CITY OF SAN ANTONIO  
TRANSPORTATION & CAPITAL IMPROVEMENTS  
Seeling Channel Phase II Drainage #40-00427

**ADDENDUM NO.1**

March 20, 2015

**TREE PRESERVATION PLAN V**  
 4 (ALT 1) OF 4

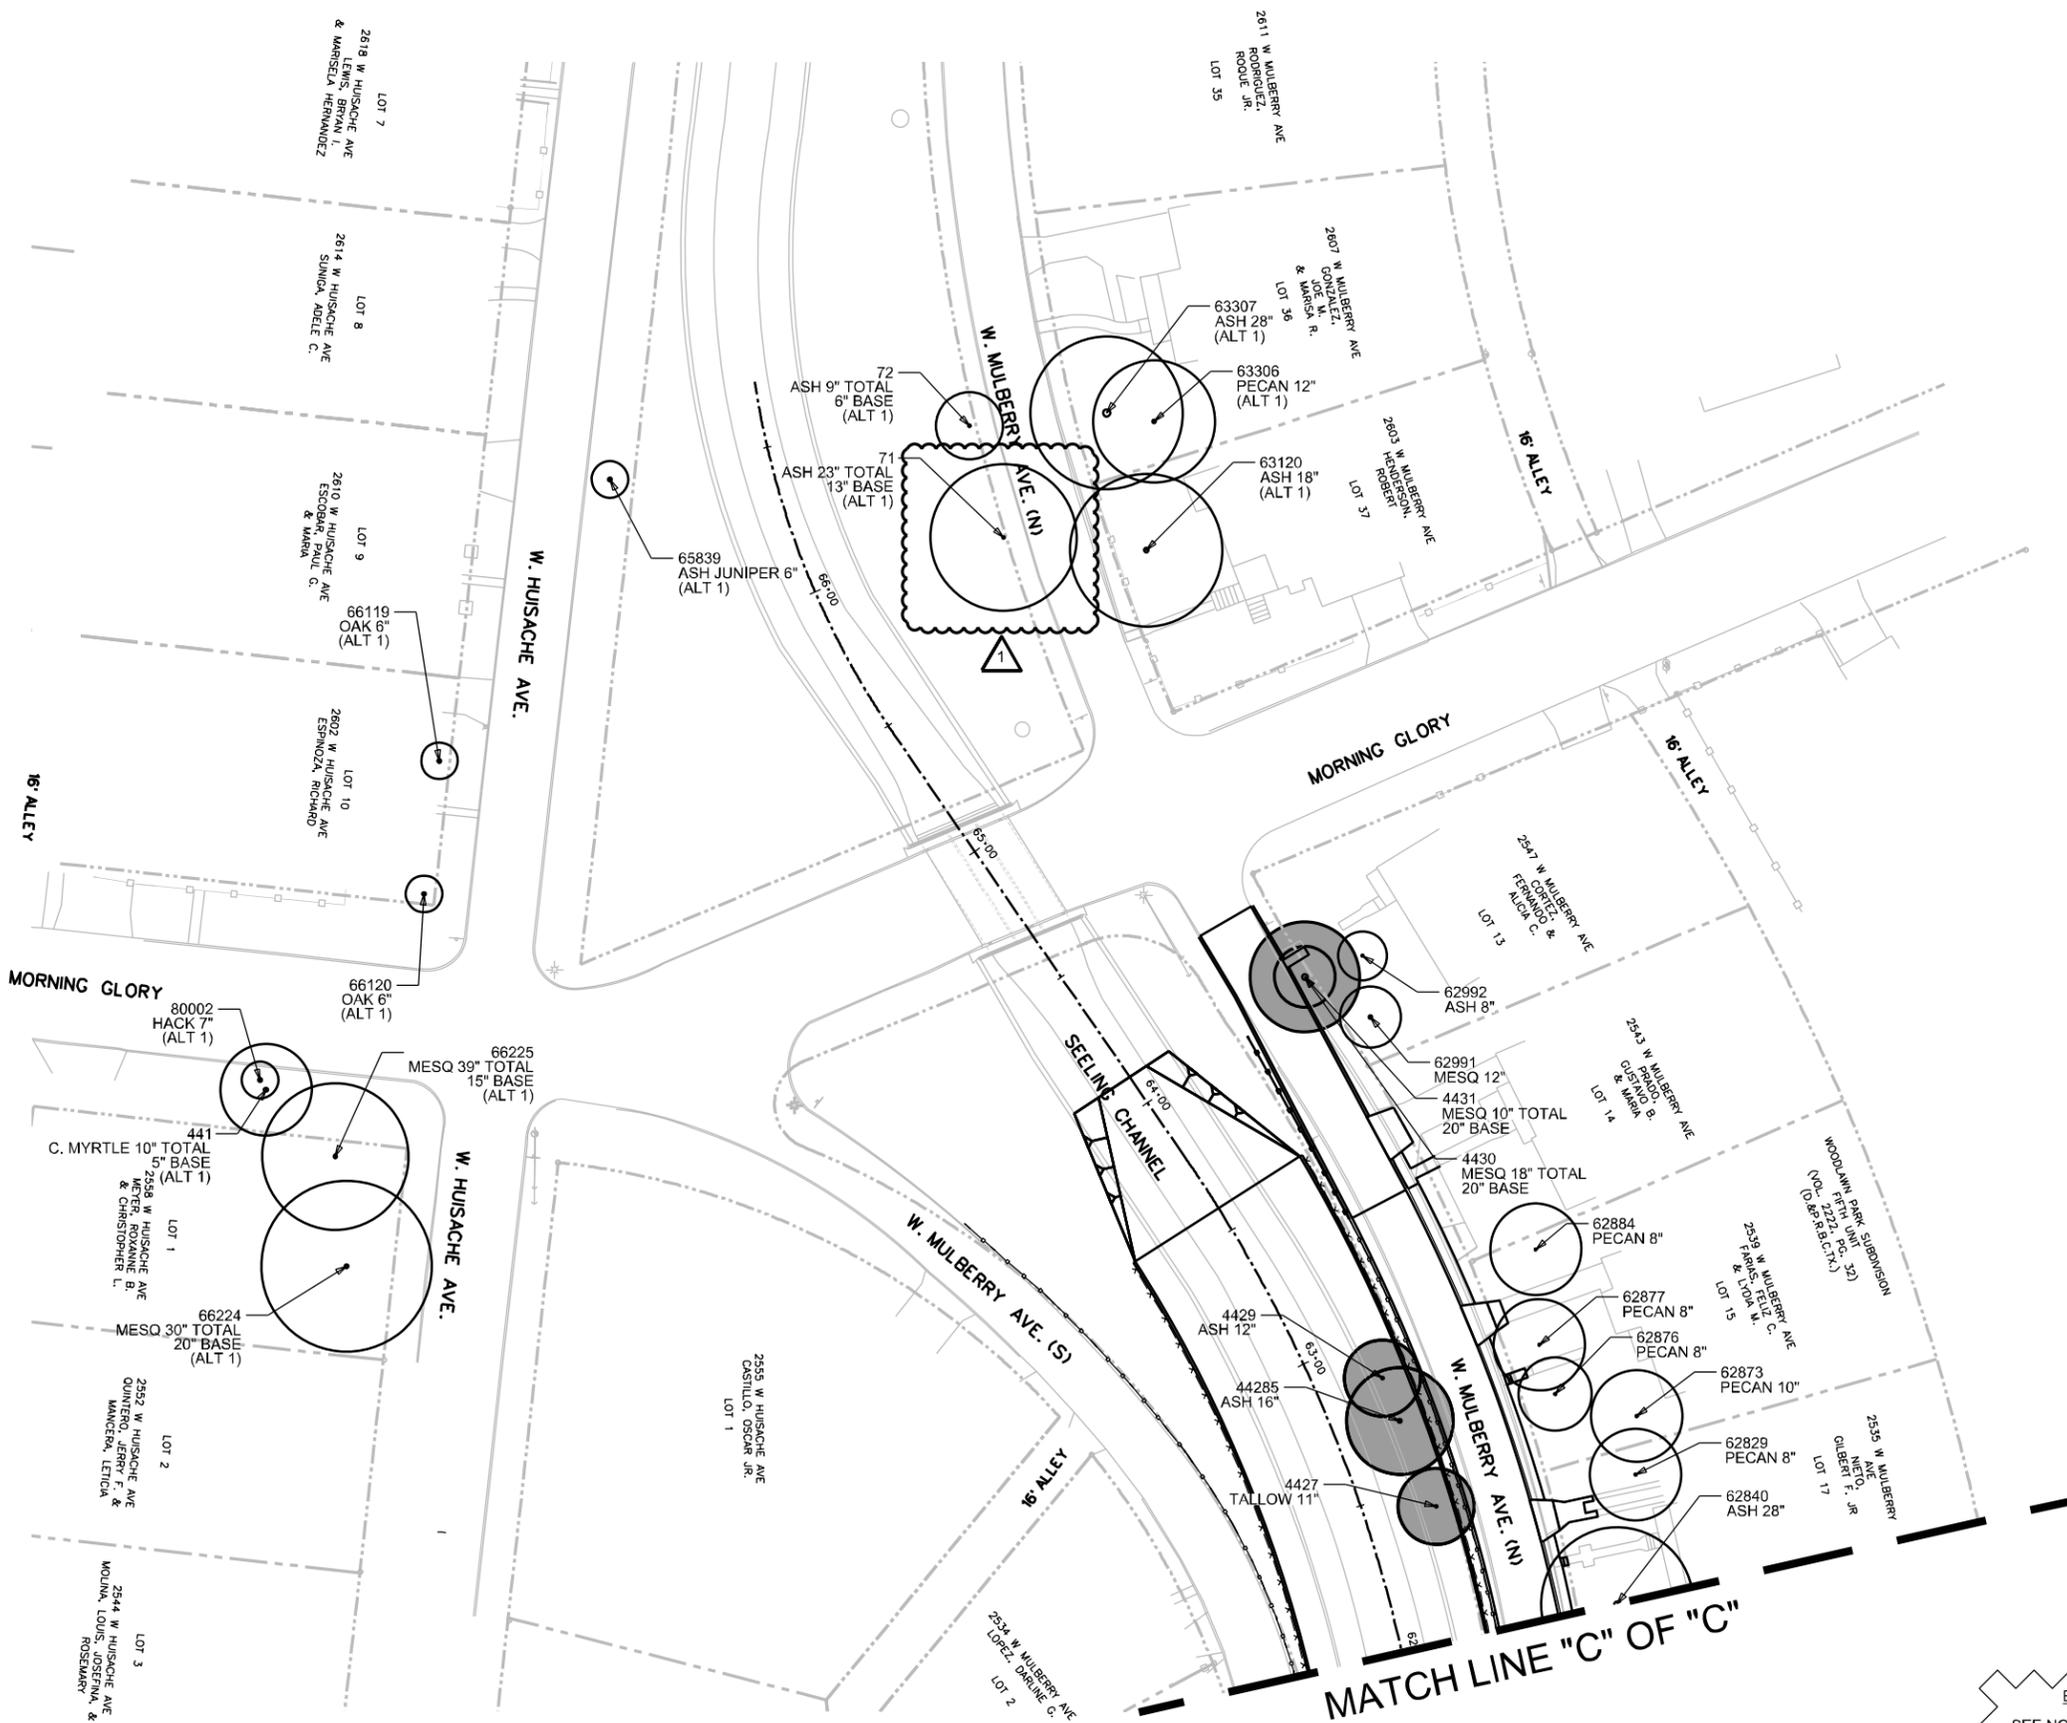
1. Revisions to Sheets 131, 132, 133, and 135. Tree #71 is no longer marked to be counted towards the overall removed tree count.

NO	DATE	DESCRIPTION	DWG	CHK
1	3/19/2015	Addendum 1, Tree 71 Preserved

**TREE PRESERVATION PLAN IV**  
4 (BASE) OF 4

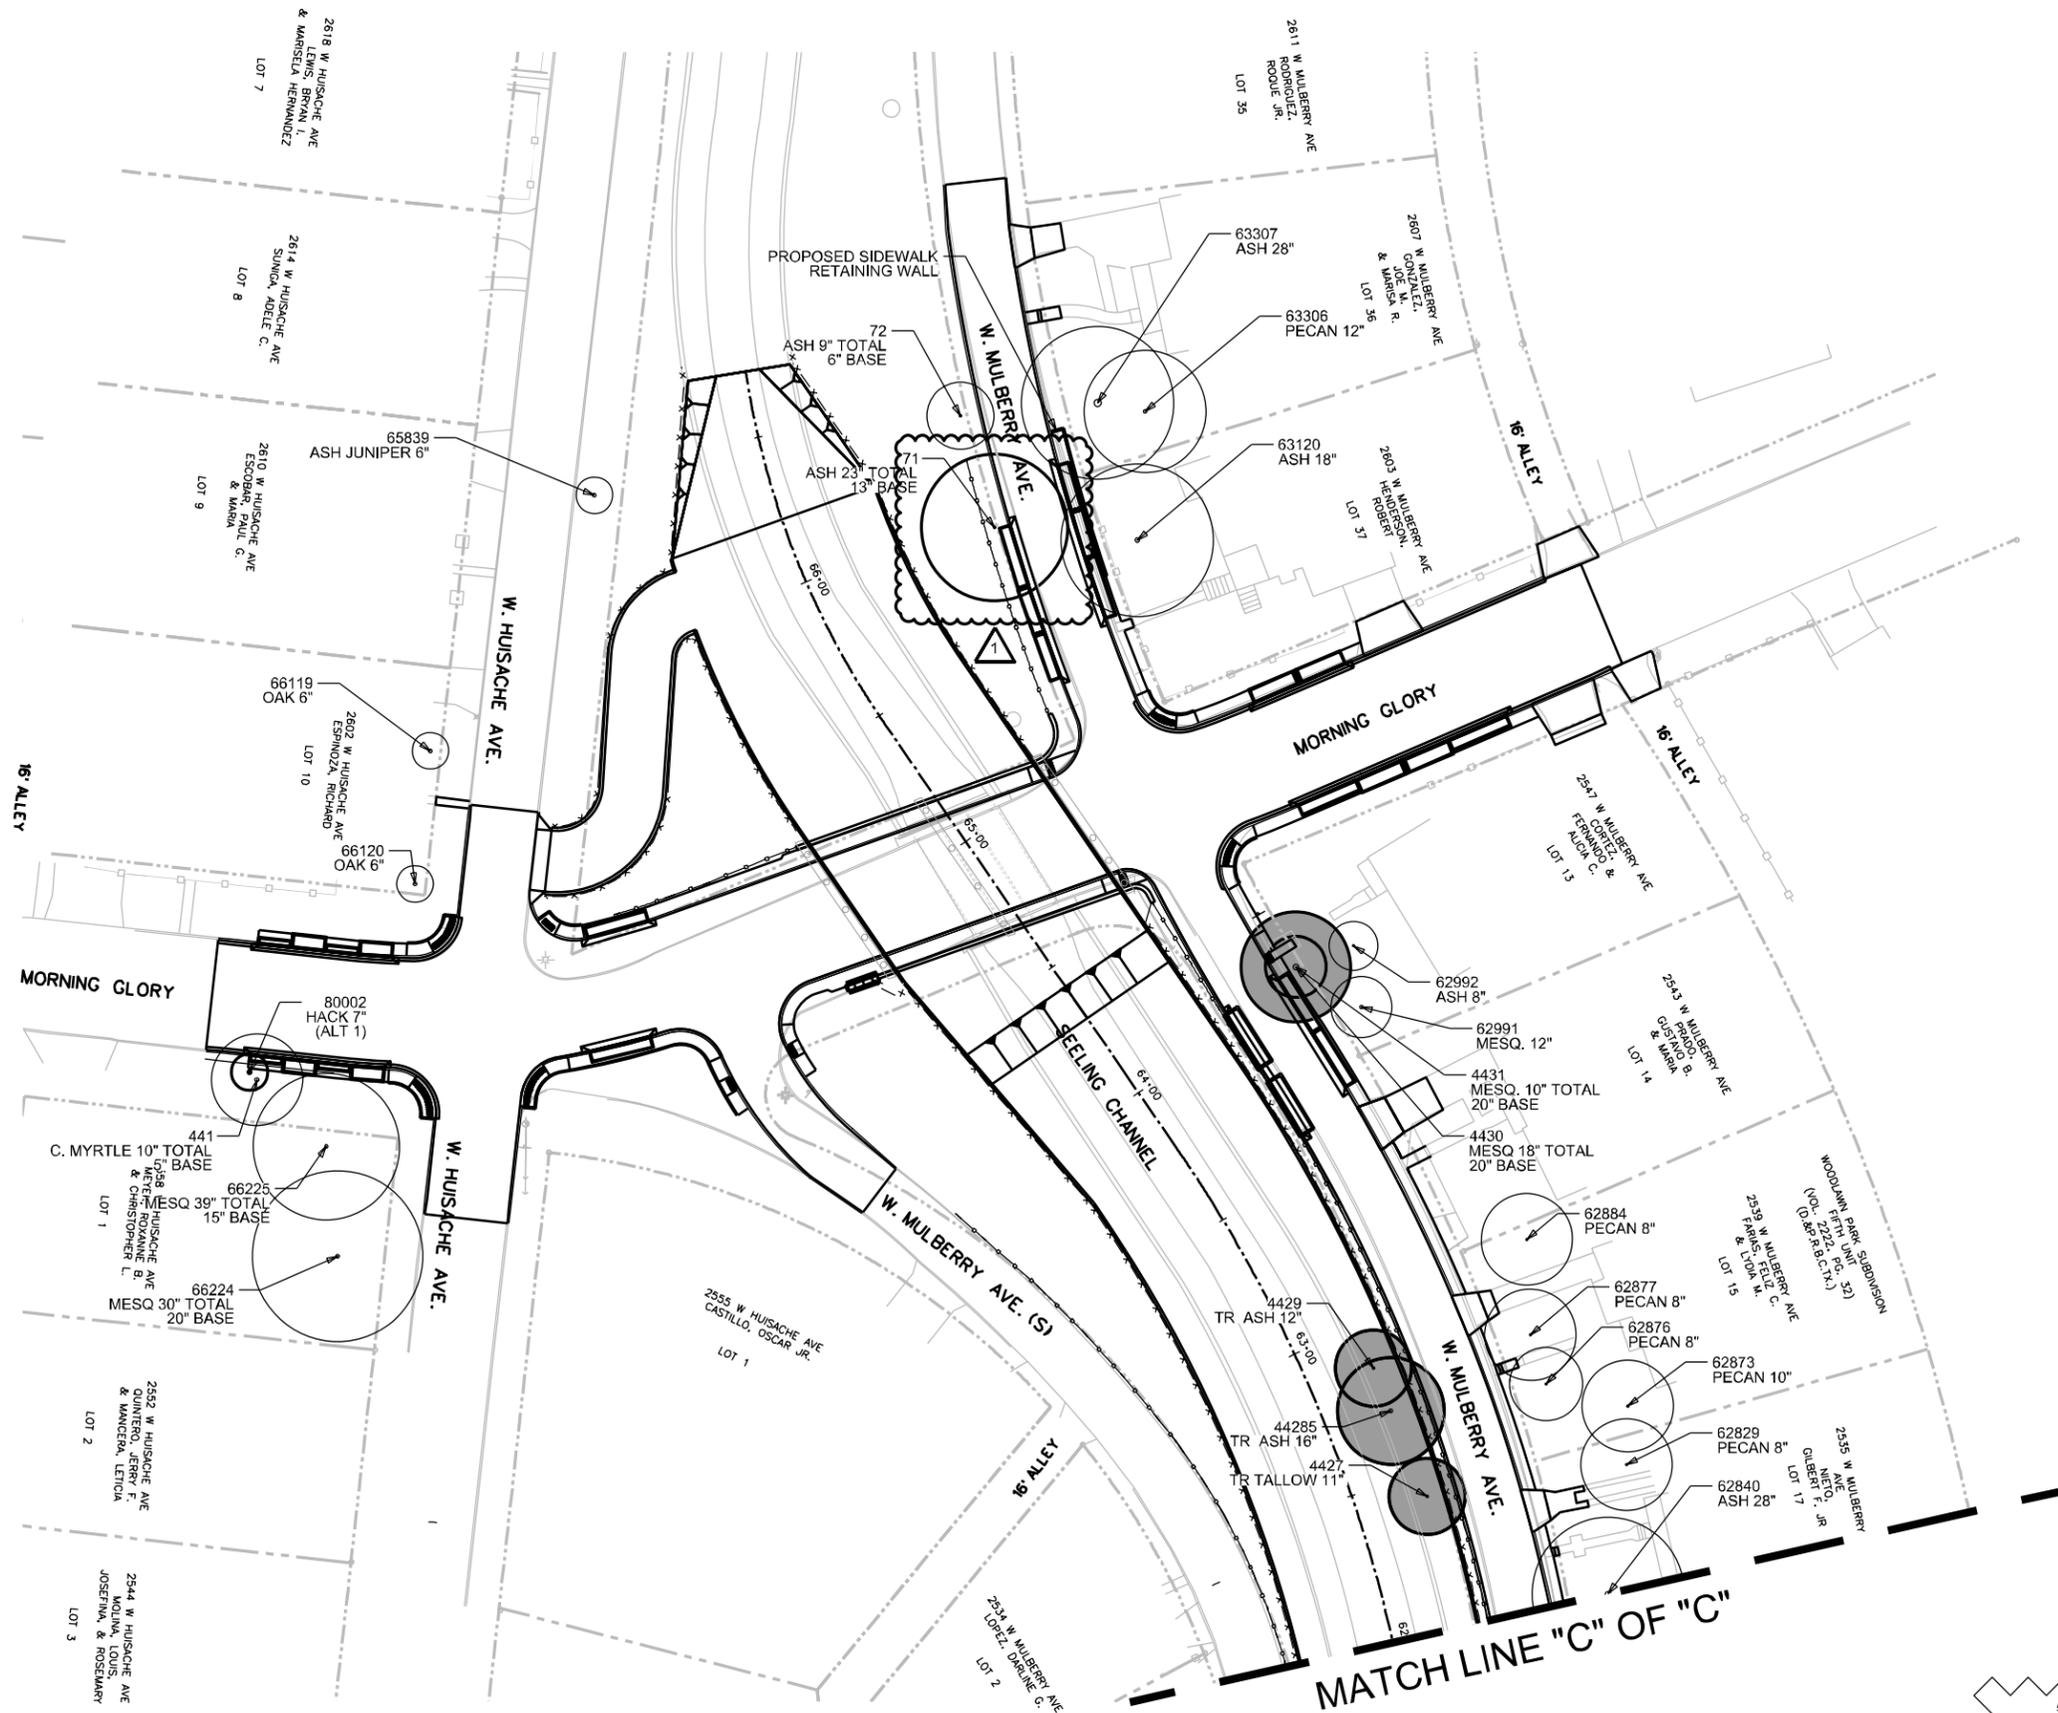
1	3/19/2015	Addendum 1, Tree 71 Preserved		
NO	DATE	DESCRIPTION	DWG	CHK
		REVISIONS
